Santa Cruz Downtown Plan Expansion Final Subsequent EIR

April 2025
SCH #: 2022090276

City of Santa Cruz

Kimley-Horn & Associates

Baseline Scenario (Existing Zoning and General Plan)

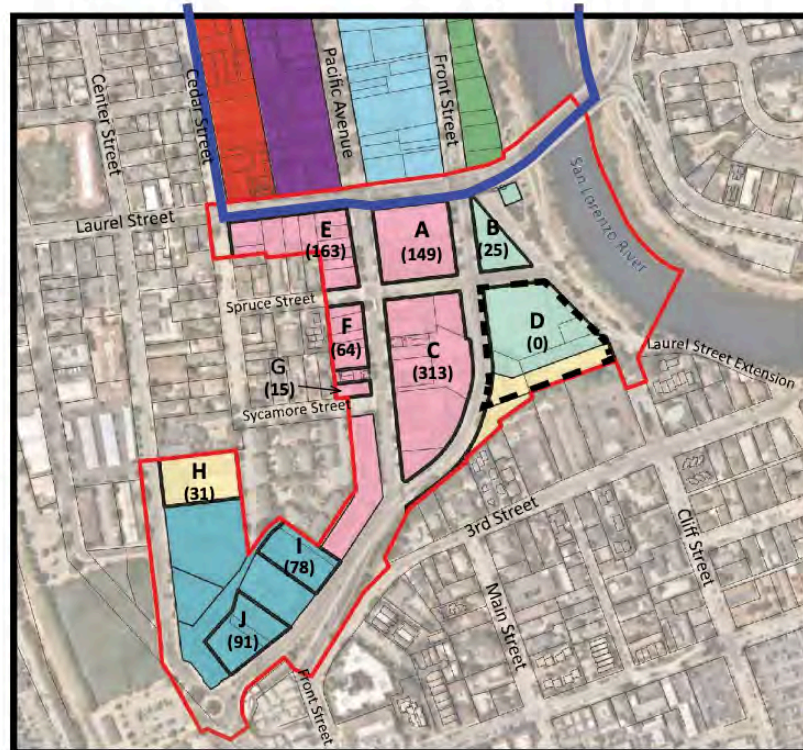
This is forecasting in bad faith and the EIR's projections *must redo their analysis (traffic, environmental etc.) for scenarios wherein there's a 75% or even 100% density bonus applied. "It probably won't happen" doesn't suffice as mitigation here, because it still can happen. Can you show the effects, empirically, that would result from your proposed upzoning PLUS developers taking advantage of a 100% density bonus on top of that? Where in this EIR are there calculations from a traffic, congestion, emissions, water use and biological (flora and fauna) standpoint? Please provide.*

GP63-2

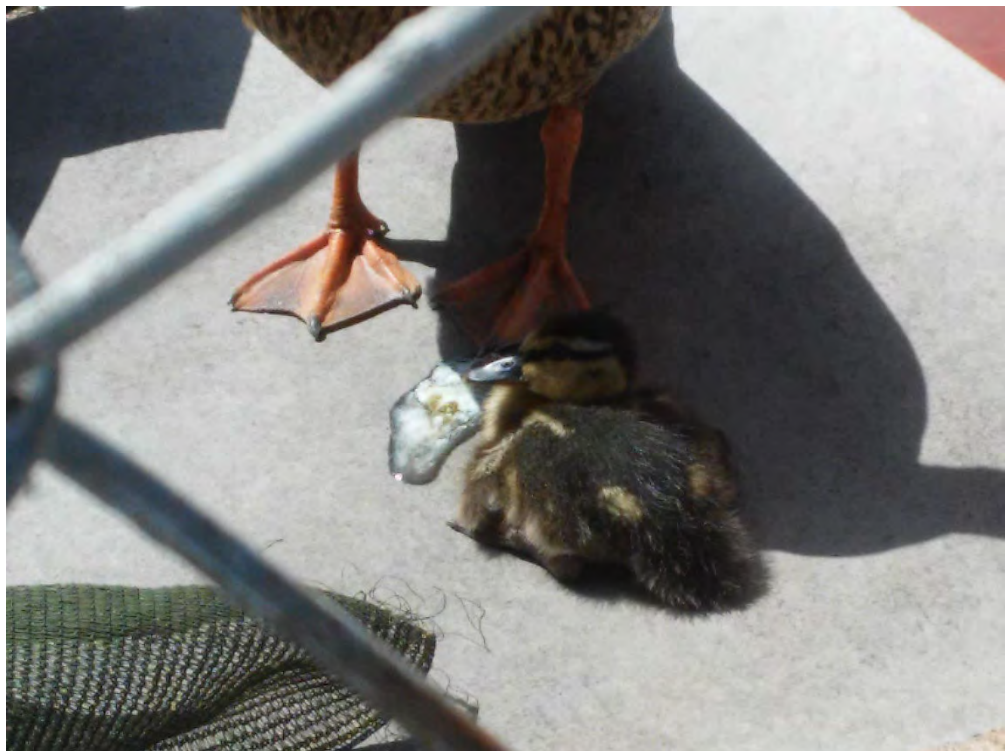
4.4.18 Comment GP63: Pablo Yale**Comment GP63-1: Potential Bird Impacts**
